Apollo Main 15 Parachute Failure

Potential Effects of Failure

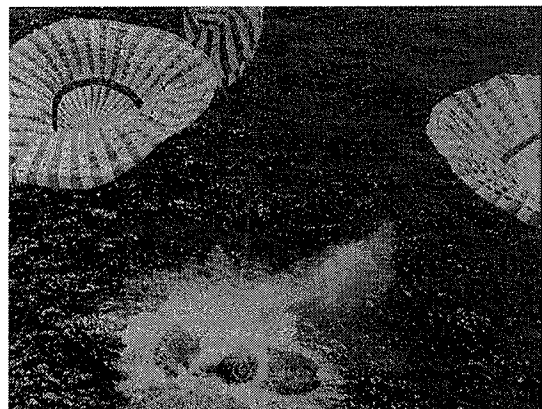
Your severity [#] for Apollo failure is too high given the level of redundancy.

occ also high - low
